**Item 5.****Section 4.55 Application: 44-48 O'Dea Avenue Waterloo (Building C)**

File No.: D/2016/1450/F

**Proposal Summary:** This application is made pursuant to Section 4.55(2) of the Environmental Planning and Assessment Act 1979 (EP&A Act 1979) to modify the concept development consent D/2016/1450/E. The application should be read in conjunction with the detailed design development application D/2018/802, which is submitted to the Central Sydney Planning Committee (CSPC) for concurrent consideration.

Figure 3: The proposed building envelope

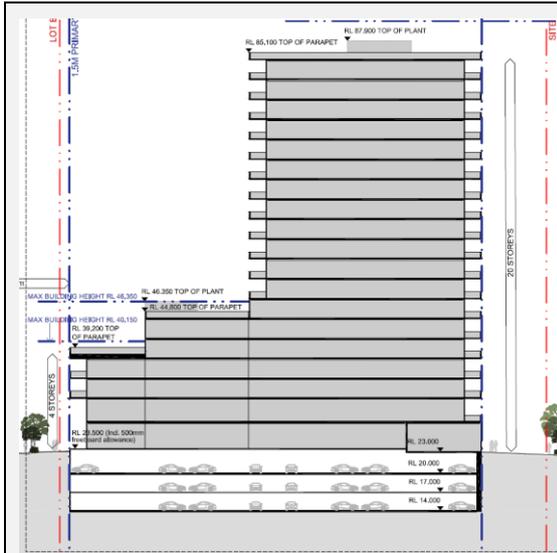
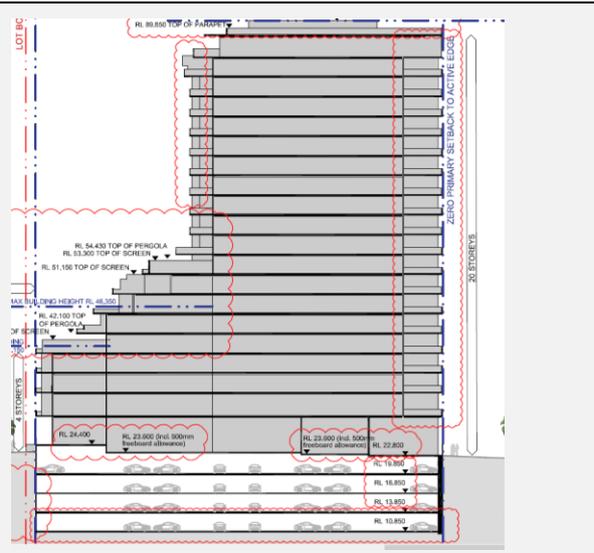
12. Figures 2 and 3 below show the approved and proposed building envelopes. The proposed modifications include:
- the addition of a fourth basement level;

- the addition of an additional storey within the maximum permitted height; and
  - variations to the form of the podium of Building C that has resulted from winning scheme of the competitive design process. Specifically, in order for the envelope to be consistent with the detailed design development application, the proposal seeks to increase the length of the tower over the lower podiums and increase the heights of the podiums.

Figure 4: The plan highlights the areas of the detailed design (development application D/2018/802) that exceed the maximum height of buildings standards

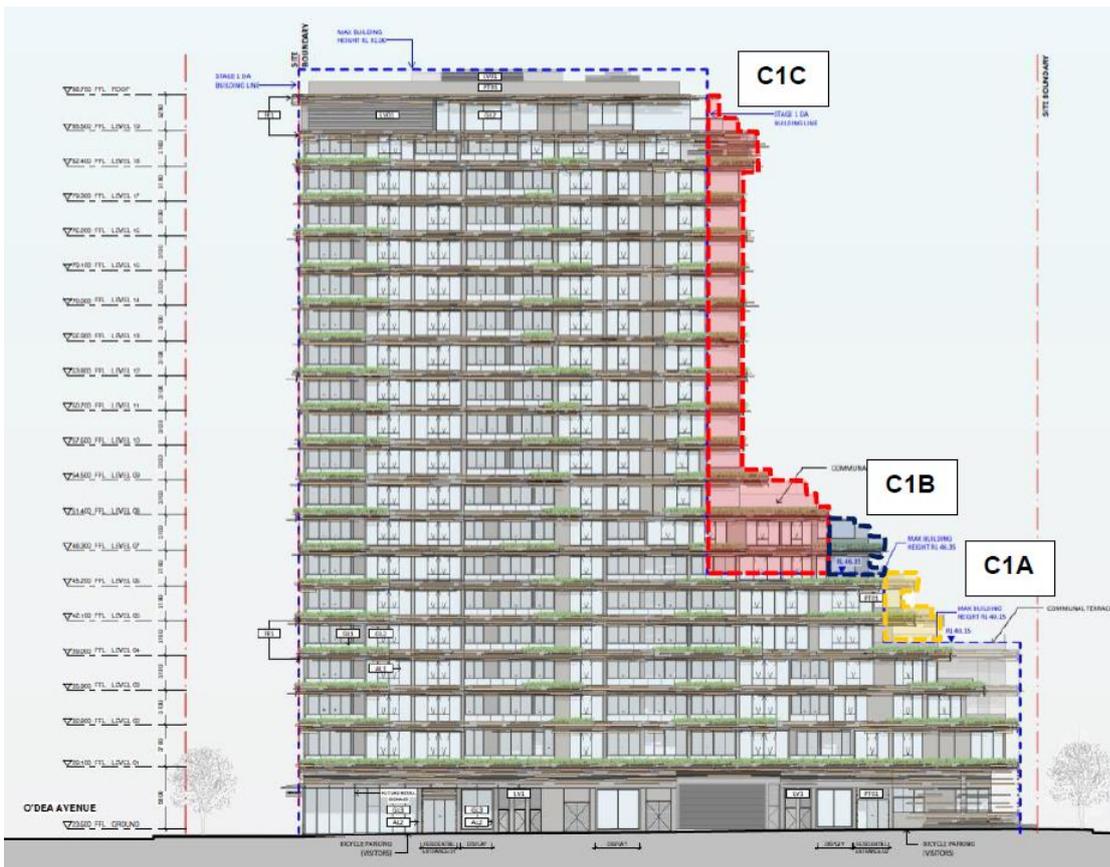
13. Figure 4, below, illustrates the areas where the detailed design development application seeks to vary the existing approved building envelope for Building C. These highlighted areas are the modifications sought to building envelope under the subject application to ensure that the staged development applications remain consistent as required under the provisions of the Environmental Planning and Assessment Act 1979.

Figure 7: A comparison of the approved building envelope in blue and the proposed building envelope in red

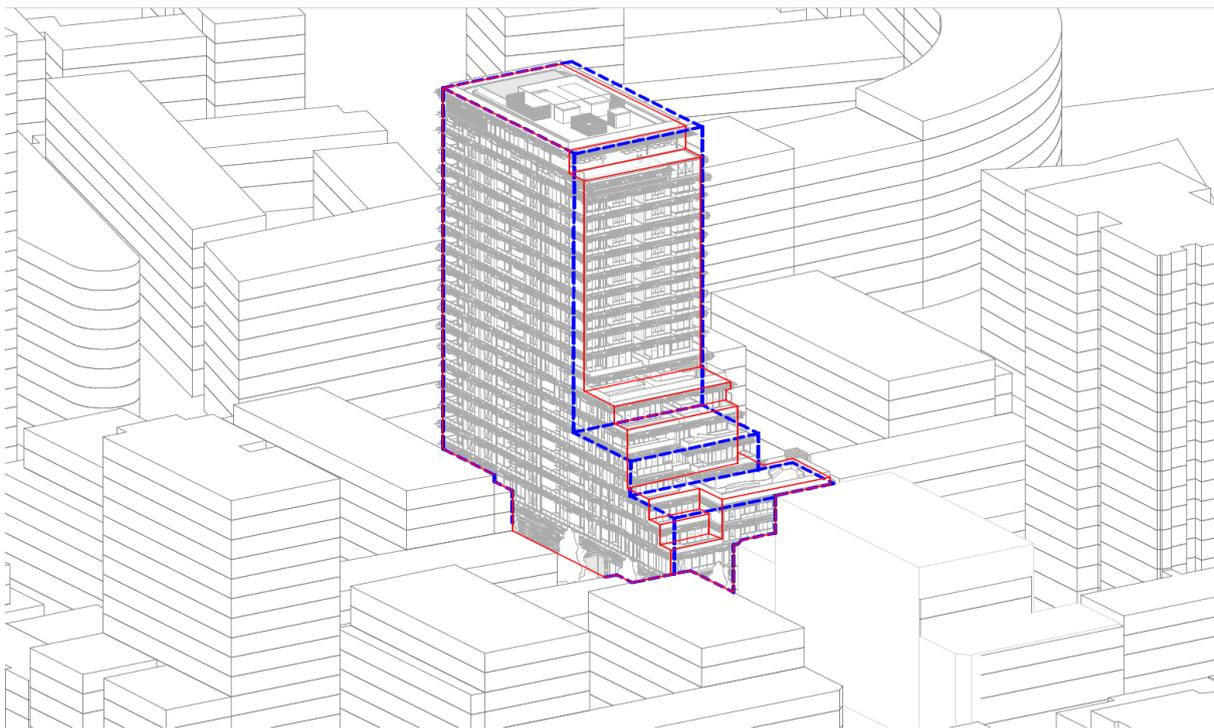
32. The application proposes to modify the approved building envelope such that it will exceed the maximum height of buildings development standards for components C1A and C1B and the maximum height in storeys control.

33. Variations to the maximum height of buildings development standards by way of Section 4.55 applications are not subject to the provisions of Clause 4.6 of the Sydney LEP 2012. However, the detailed design development application exceeds the numerical height of buildings development standards and is therefore subject to the provisions of Clause 4.6.

34. As discussed in that report, the applicant has submitted a written request to demonstrate that compliance with the height standard is unreasonable and unnecessary, and that there are sufficient environmental planning grounds to support the extent of the variation proposed in the circumstances of the case. Notwithstanding the non-compliance with the numerical standard, the development is considered to be consistent with the objectives of the height of buildings development standard and the B4 - Mixed Use zone objectives. The variation to the height standard is therefore considered to be in the public interest.

Figure 8: A view from the sun diagram at 1pm during midwinter. The approved envelope is in blue, while the amended envelope is in red

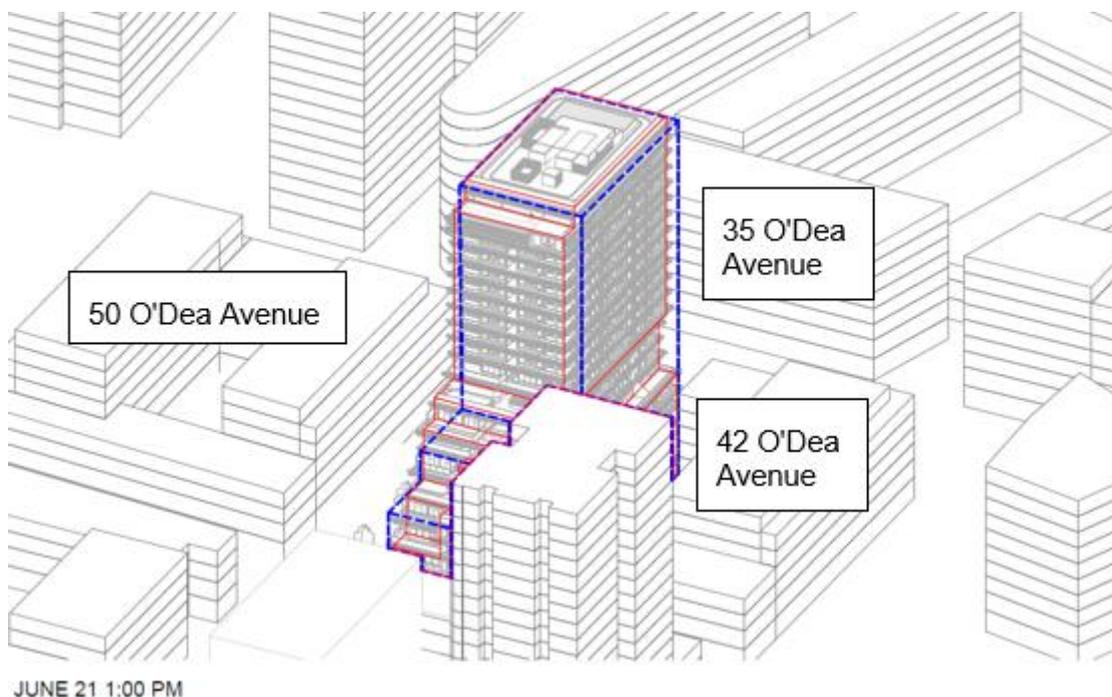
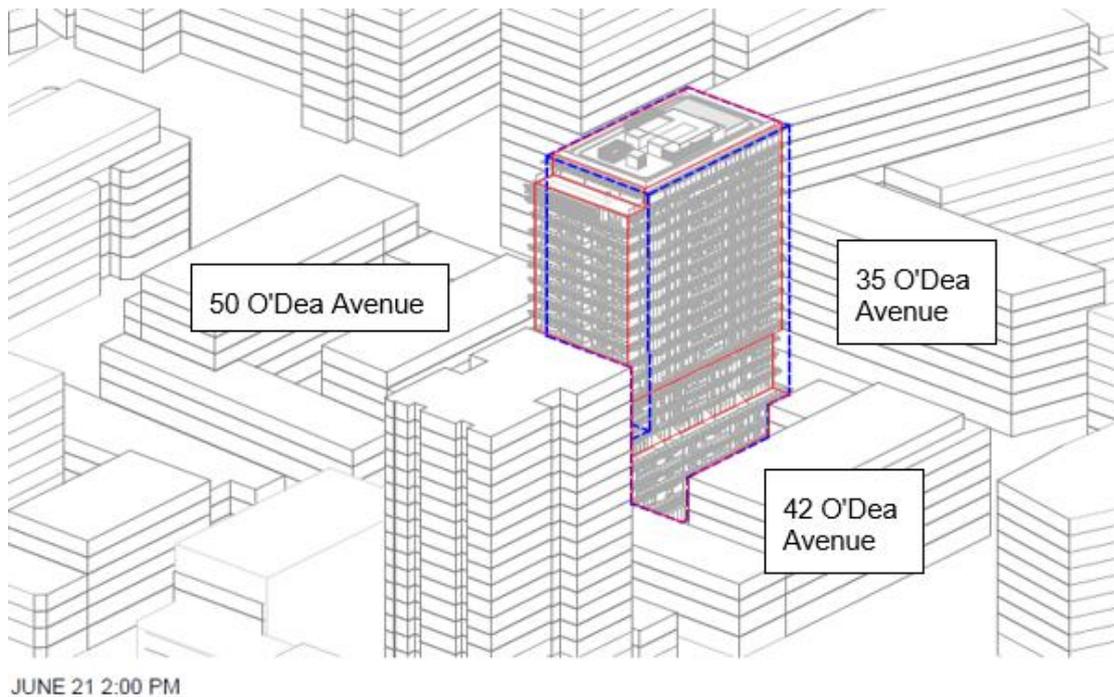
43. The applicant has provided views from the sun diagrams (see attachment B) that illustrate the impact of the additional bulk. Particular regard is paid to the indicative building envelopes at 42 O'Dea Avenue to the west and 50 O'Dea Avenue to the east. While these sites do not currently accommodate dwellings, the planning controls for the Lachlan Precinct envisage a mixed use building with residential apartments. While it is difficult to determine the future location and number of residential apartments within the adjoining sites (or confirm any future use considering they are located within the B4 - Mixed Use zone), this assessment has considered the impact on these envelopes to ensure that they are not unduly prejudiced in the future from residential development.

44. The views from the sun diagrams demonstrate that additional shadow will be cast to the western elevation of the building envelope of 50 O'Dea Avenue from approximately 1pm during midwinter. The northern and internal western elevations of the building envelope will continue to receive more than two hours solar access during midwinter. As such, the amended building envelope will not overshadow 50 O'Dea Avenue such that it would preclude residential development of the site.

Figure 10: A view from the sun diagram at 9am during midwinter. The approved envelope is in blue, while the amended envelope is in red

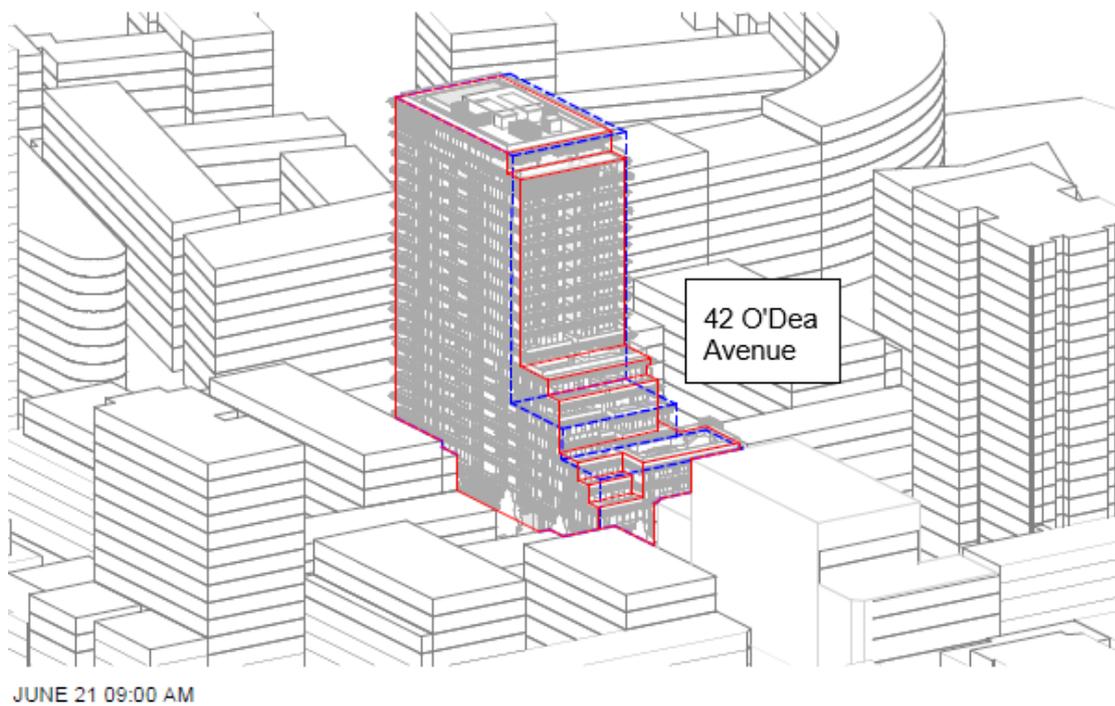
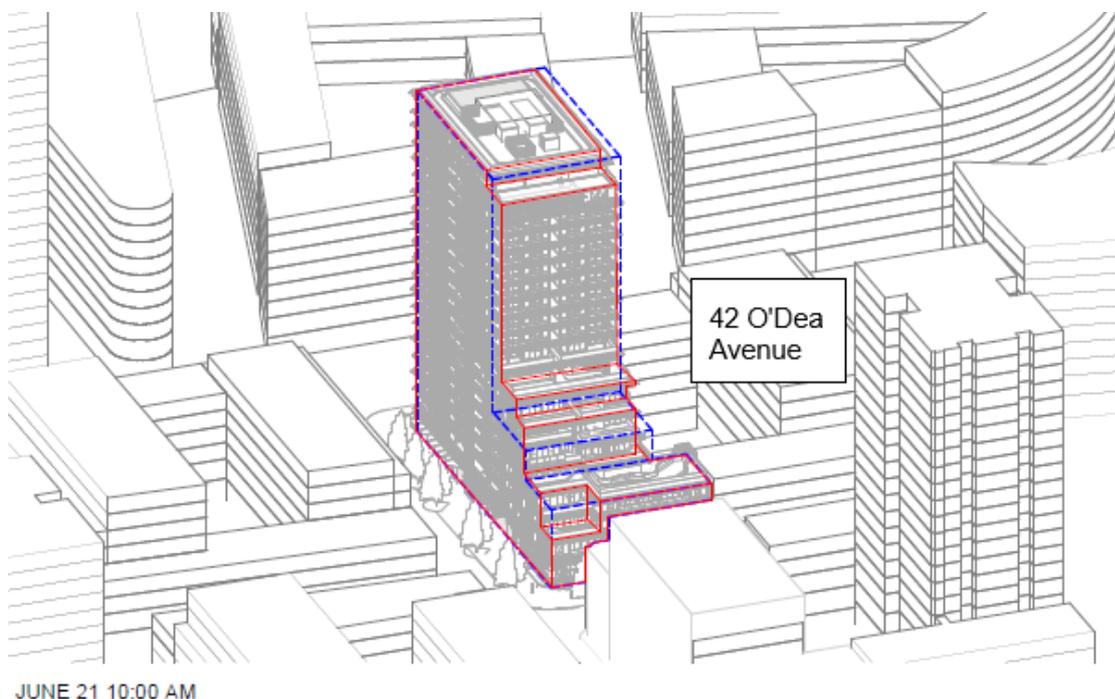
45. The views from the sun diagrams illustrate additional overshadowing of 42 O'Dea Avenue up to 10am during midwinter, specifically the northern elevation of the six storey component fronting O'Dea Avenue. The north and west elevations will continue to receive more than two hours solar access during midwinter. As such, the amended building envelope will not overshadow 42 O'Dea Avenue such that it would preclude residential development of the site.

- 46. The amended building envelope therefore satisfies Objective 3B-2 of the Apartment Design Guide.
